Town of Essex, Vermont
Application for Zoning Permit
www.essex.org

Application Date __/__/__
Permit Number 2019-046

TOWN OF ESSEX, VERMONT
APPLICATION FOR CURB CUT / UTILITY PERMIT

63 Indian Brook Rd

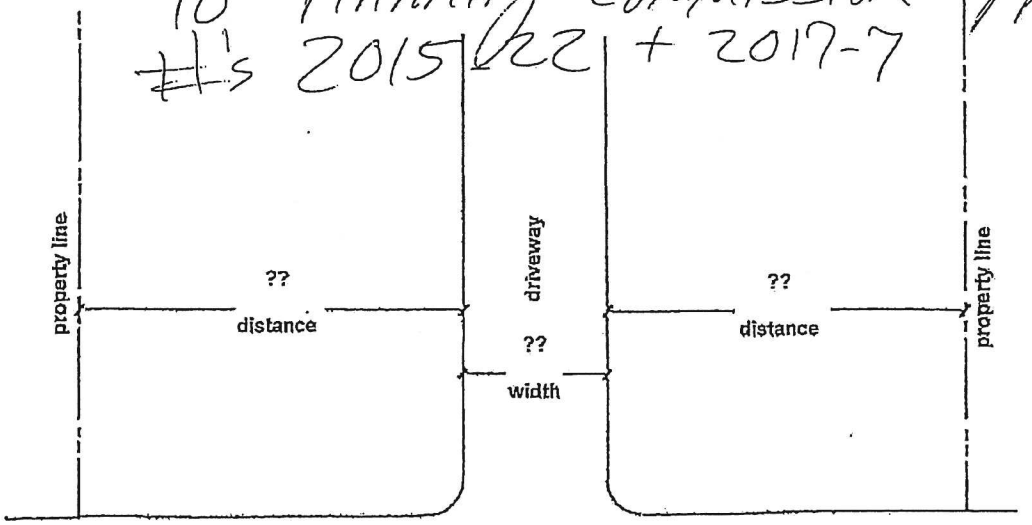
- APPLICANT TO CLEAR ALONG THE ROAD FRONTAGE R.O.W. TO ACCOMODATE ROAD SIDE DITCH LINE.
- APPLICANT TO EXCAVATE DITCHLINE ALONG THE FRONTAGE R.O.W. TO ACCOMODATE DRIVEWAY CULVERT (REQUIRED) AS SHOWN ON THE ATTACHED DETAIL FOR RURAL DRIVEWAY.
- DRIVEWAY MAY BE 15' WIDE FOR THE ACCOMODATION OF THE TWO LOTS BEING SERVICED.
- DRIVEWAY LAYOUT AND GRADING IS TO CONFORM THE THE ATTACHED DETAIL FOR RURAL DRIVEWAY.
- MINIMUM CULVERT DIAMETER IS 18 INCHES.
